# UNITED STATES PATENT AND TRADEMARK OFFICE

APPLICATION NO.	FILING DATE	FIRST NAMED INVENTOR	ATTORNEY DOCKET NO.	CONFIRMATION NO.
10/750,433	12/30/2003	Michael R. Clark	31419.23990	1979

<b>Office Action Summary</b>	Application No. 10/750,433	Applicant(s) CLARK ET AL.	
	Examiner Vinh T. Luong	Art Unit 3682

# **ATTACHMENT 1**

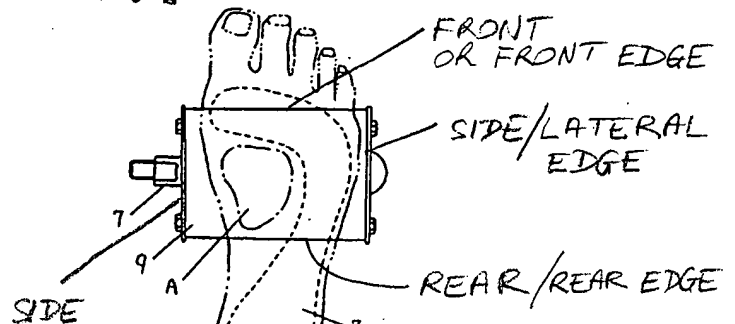
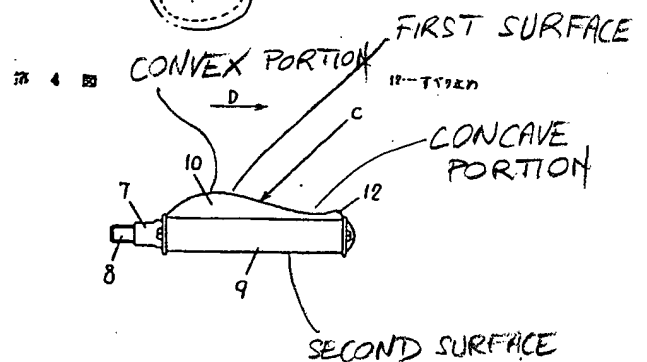
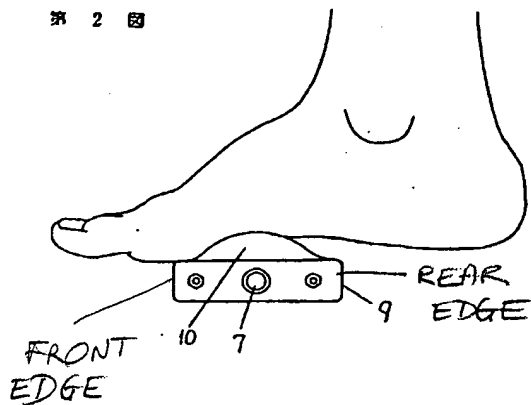
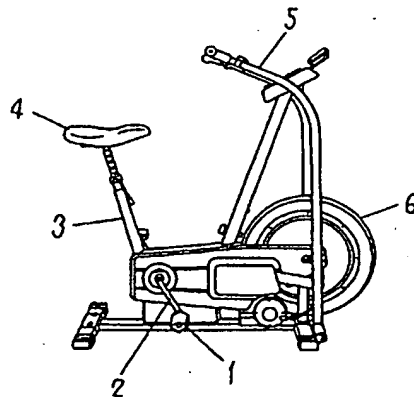
Regarding claim 1, Mitsuo teaches an apparatus 1, comprising: a reversible pedal body 9, 10 having first and second surfaces (at C and 9 in Fig. 4. See Attachment 1), wherein said first surface (C) is adapted to contact an associated foot B, said second surface (9) is adapted to contact an associated shoe, said reversible pedal body being a single part 9, 10, said pedal body 9, 10 having a front (Att. 1) oppositely disposed from a rear (Att. 1), said pedal body having first and second lateral edges (Att. 1) extending between said front and said rear, said pedal body 9, 10 being operatively connected to an associated exercise device 2-6.

Regarding claim 2, said first surface (Att. 1) is curved.

Regarding claim 3, said first surface (Att. 1) further comprises a concave portion (Att. 1) and a convex portion (Att. 1) so as to *substantially* conform to an arch A of the foot B. See English abstract.

Regarding claim 4, said first surface (Att. 1) further comprises: a front edge *substantially* flush with said rear of said pedal body; and a rear edge *substantially* flush with said front of said pedal body 9, 10 as seen in Fig 2.

Regarding claim 5, said front edge (Att. 1) is left or right directional.

Regarding claim 12, Mitsuo teaches a foot pedal for an exercise device, comprising: a reversible pedal body 9, 10 having first and second surfaces (Att. 1), wherein said first surface (Att. 1) is adapted to contact an associated foot B, said first surface (Att. 1) being curvilinear, said second surface (Att. 1) is adapted to contact an associated shoe, said pedal body 9, 10 having a front (Att. 1) oppositely disposed from a rear (Att. 1), said pedal body 9, 10 having first and second lateral edges (Att. 1) extending between said front (Att. 1) and said rear (Att. 1), said pedal body 9, 10 being operatively connected to an associated exercise device 2-6.

Regarding claim 13, said first surface (Att. 1) further comprises a rear edge (Att. 1), said first surface (Att. 1) has a concave portion (Att. 1) transitioning into a convex portion (Att. 1).

FIG. 3

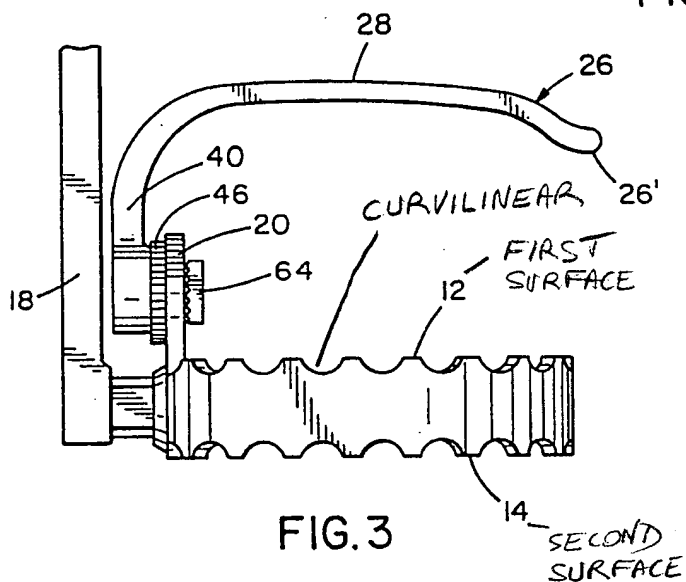
Regarding claim 1, Loppnow teaches an apparatus 10, 10' comprising: a reversible pedal body 12 having first and second surfaces (at 12 and 14 in Fig. 3. See Attachment 2), wherein said first surface (Att. 2) is adapted to contact an associated foot, said second surface (Att. 2) is adapted to contact an associated shoe (Fig. 9 and 10), said reversible pedal body 12 being a single part 12, said pedal body 12 having a front (Att. 2) oppositely disposed from a rear (Att. 2), said pedal body 12 having first and second lateral edges 20 and 20 (Fig. 5) extending between said front (Att. 2) and said rear (Att. 2), said pedal body 12 being operatively connected to an associated exercise device 22.

Regarding claim 12, Loppnow teaches a foot pedal for an exercise device, comprising: a reversible pedal body 12 having first and second surfaces (Att. 2), wherein said first surface (Att. 2) is adapted to contact an associated foot, said first surface (Att. 2) being curvilinear (Att. 2), said second surface (Att. 2) is adapted to contact an associated shoe (Figs. 9 and 10), said pedal body 12 having a front (Att. 2) oppositely disposed from a rear (Att. 2), said pedal body 12 having first and second lateral edges (Att. 2) extending between said front (Att. 2) and said rear (Att. 2), said pedal body 12 being operatively connected to an associated exercise device 22.

# **ATTACHMENT 2**

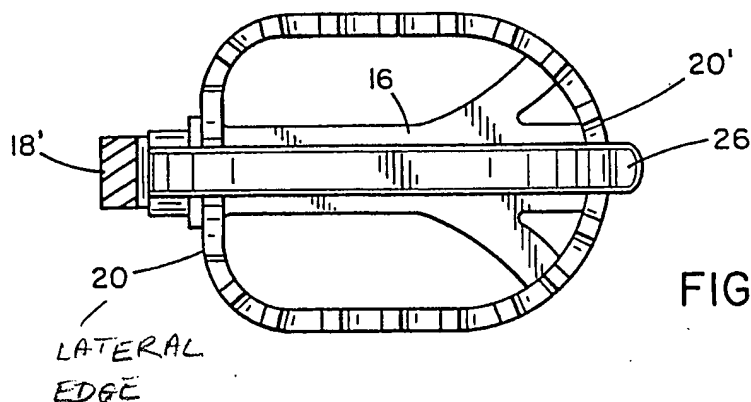
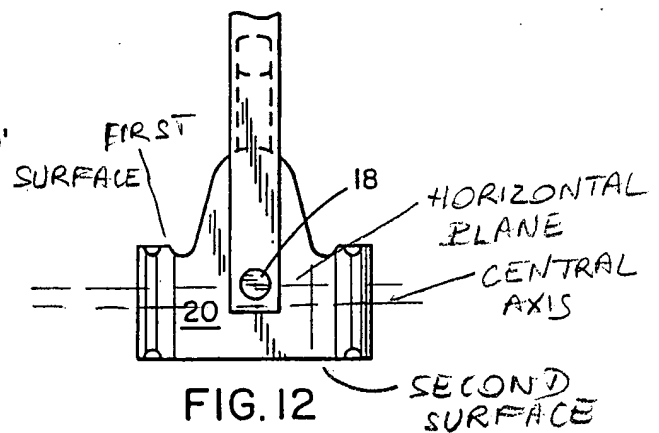
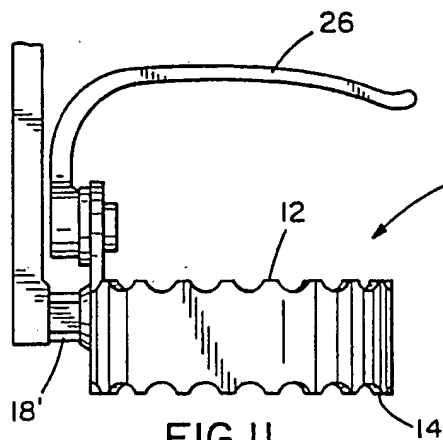
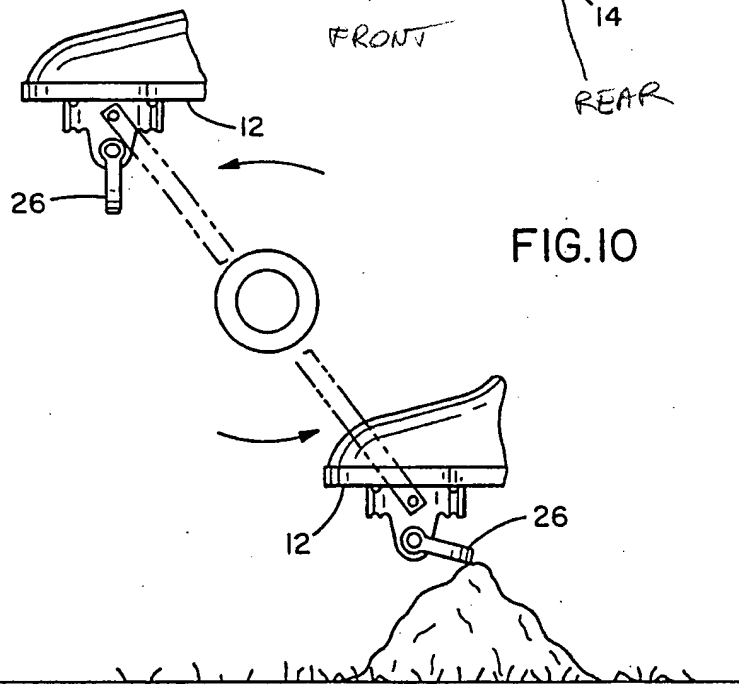
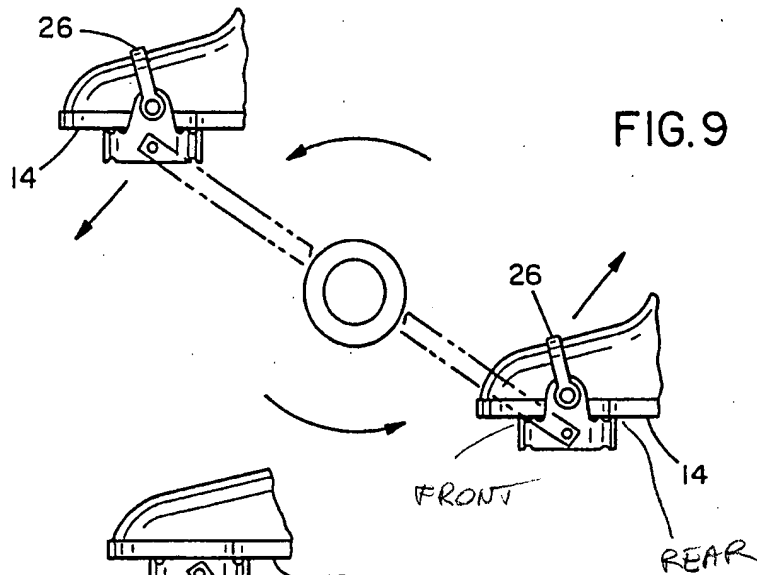
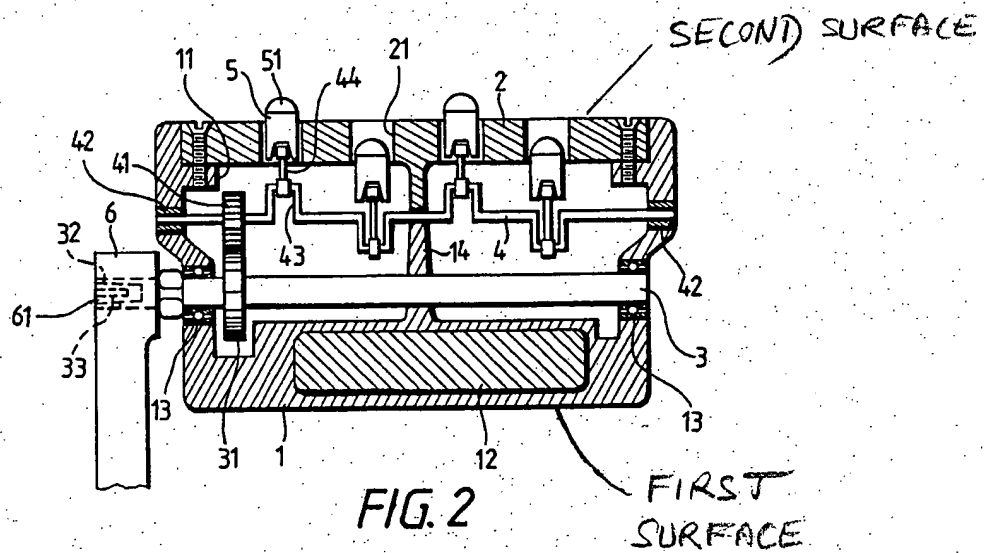
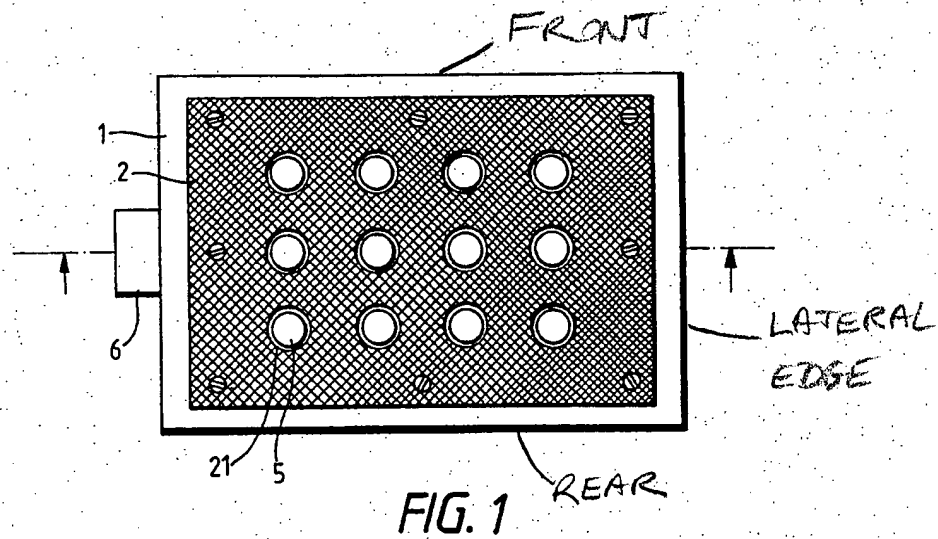
Regarding claim 9, Loppnow's apparatus further comprises securing means 26 operatively connected to said pedal body 12, wherein said securing means 26 is adapted to rotate substantially 360 degrees around said pedal body 12. See Figs. 9 and 10 and col. 3, line 59 through col. 5, line 30.

Regarding claim 19, Loppnow's reversible foot pedal further comprises a horizontal plane (passing the axis of rotation of the bolt 18' in Figs. 11 and 12) between said first and second surfaces (Fig. 12 of Att. 2); and at least one weight 16 (Fig. 2) having a central axis (lying on the central, horizontal, bisecting plane of the main pedal portion 12. See Fig. 12 of Att. 2),

wherein said central axis (Fig. 12 of Att. 2) is displaced from said horizontal plane (Fig. 12 of Att). Note that the spline 16 inherently has a weight since it is inherently subjected to gravitational force exerted by the earth. The weight of the spline 16 urges the center of gravity of the pedal system 10' such that the pedal 10' is normally oriented in its upright state as explicitly described in col. 5, lines 31-40. Therefore, the weight of the spline 16 "reads on" the claimed weight.

Regarding claim 20, said first surface (Att. 2) is adapted to contact an associated foot and said second surface (Att. 2) is adapted to contact an associated shoe. See Figs. 9 and 10.

# **ATTACHMENT 3**

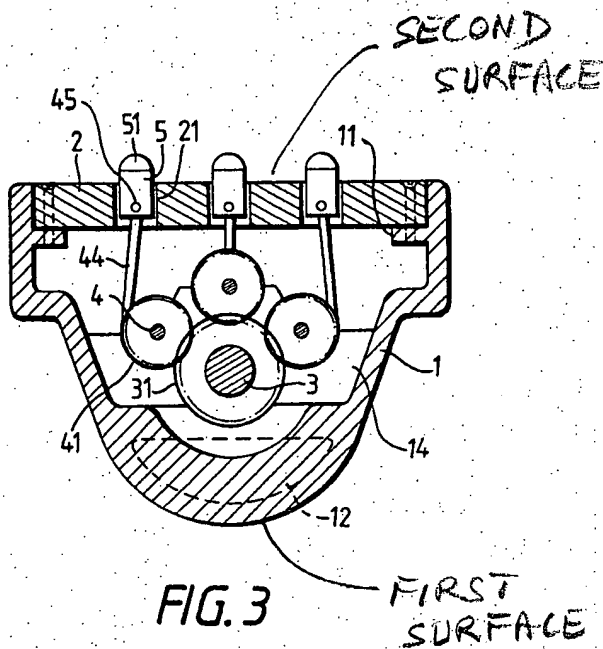
Regarding claim 1, Jean teaches an apparatus comprising: a reversible pedal body 1 having first and second surfaces (at 2 and 1 in Fig. 2. See Attachment 3), wherein said first surface (Att. 3) is adapted to contact an associated foot, said second surface (Att. 3) is adapted to contact an associated shoe, said reversible pedal body 1 being a single part 1, said pedal body 1 having a front (Att. 3) oppositely disposed from a rear (Att. 3), said pedal body 1 having first and second lateral edges (Att. 3) extending between said front (Att. 3) and said rear (Att. 3), said pedal body 1 being operatively connected to an associated exercise device. *Ibid.* col. 1, lines 6-14, and claims 1-12.

Regarding claim 11, Jean's apparatus comprises at least one weight 12 operatively connected to said pedal body 1, such that one of said surfaces faces substantially upwards as said pedal body 1 approaches an equilibrium position.

Regarding claim 12, Jean teaches a foot pedal for an exercise device, comprising: a reversible pedal body 1 having first and second surfaces (Att. 3), wherein said first surface (Att. 3) is adapted to contact an associated foot, said first surface (Att. 3) being curvilinear (Figs. 3 and 7, Att. 3), said second surface (Att. 3) is adapted to contact an associated shoe, said pedal body 1 having a front (Att. 3) oppositely disposed from a rear (Att. 3), said pedal body 1 having first and second lateral edges (Att. 3) extending between said front (Att. 3) and said rear (Att. 3), said pedal body 1 being operatively connected to an associated exercise device.

Regarding claim 14, Jean's foot pedal further comprises at least one weight 12 operatively connected to said pedal body 1.

FIG. 3

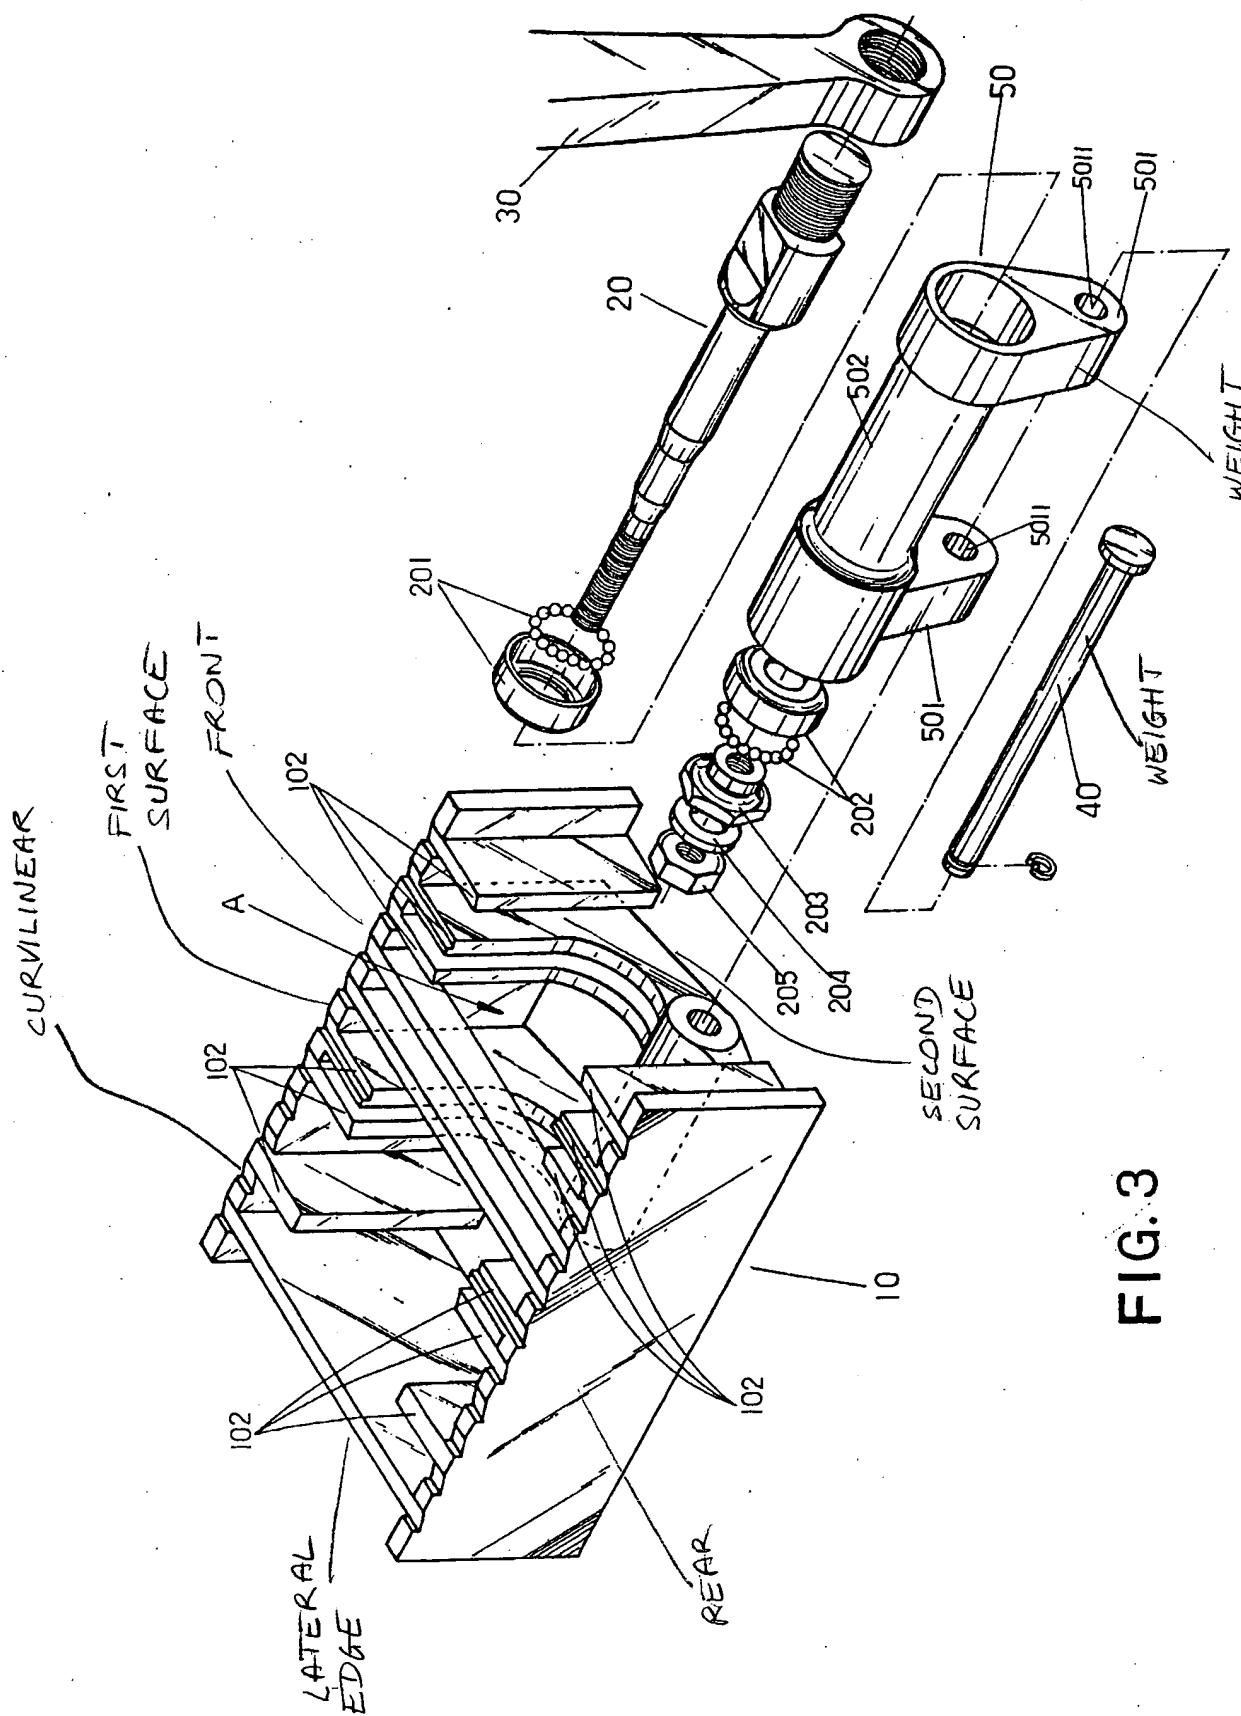
Regarding claim 12, Fan teaches a foot pedal for an exercise device, comprising: a reversible pedal body 10 having first and second surfaces (see Attachment 4), wherein said first surface (at 102 in Fig. 3) is adapted to contact an associated foot, said first surface being curvilinear (at the serrations as seen in Fig. 3, Att. 4), said second surface (Att. 4) is adapted to contact an associated shoe, said pedal body 10 having a front (Att. 4) oppositely disposed from a rear (Att. 4), said pedal body 10 having first and second lateral edges (Att. 4) extending between

Regarding claim 15, said foot pedal comprises a plurality of weights 501 and 40 operatively connected to said pedal body 10 such that one of the surfaces faces substantially upwards as it reaches an equilibrium position. Note that each of the elements 501 and 40 inherently has a weight since each of them is inherently subjected to gravitational force exerted by the earth. The weight of each of the elements 501 and 40 urges Fan's pedal in a vertical position as explicitly shown in Figs. 5-9 and described in col. 1, lines 4-64. Therefore, the elements 501 and 40 are a plurality of weights as claimed.
